UNITED STATES PATENT AND TRADEMARK OFFICE

Office Action Summary

09/941,044

Group I (claims 1-9 and 17-19), drawn to a microwave waveguide, classified in class 333, subclass 239.

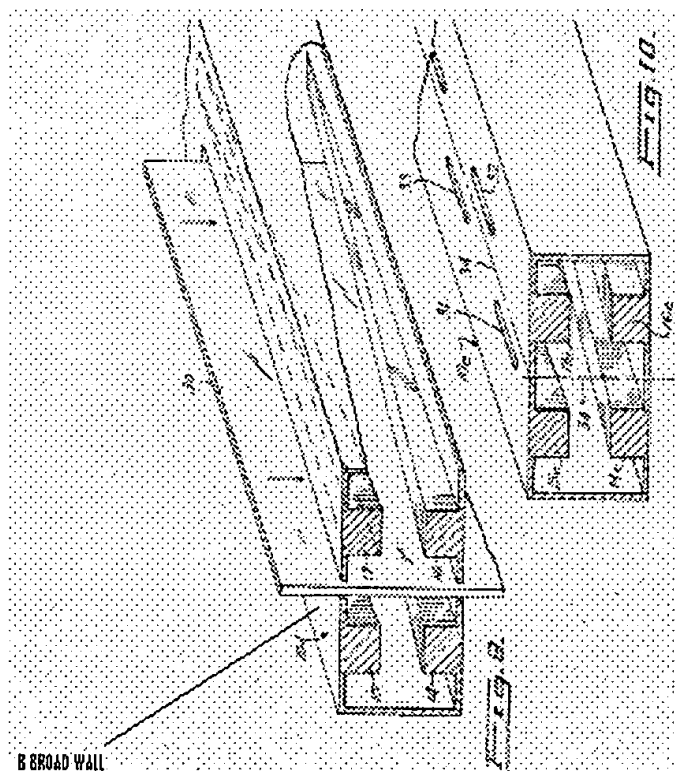
3. Claims 17 and 19 are rejected under 35 U.S.C. 102(b) as being anticipated by Bleackley (US 3,555,232). Bleackley microwave waveguides (10d) comprising broad walls (B, figure below) separated by and electromagnetically coupled with at least one narrow wall has a nonlinear profile (65, 66).

Bleackley discloses microwave waveguides (10d) comprising broad walls (B, figure below) separated by and electromagnetically coupled with at least one field modifier (14-17). Bleackley does not disclose the modifier has a nonlinear profile. Harris discloses a modifier (62) has nonlinear profile. It would have been obvious to one having ordinary skill in the art at the time the invention was made to utilize in Bleackley a modifier has nonlinear profile as taught by Harris in order to improve the uniformity of heating.
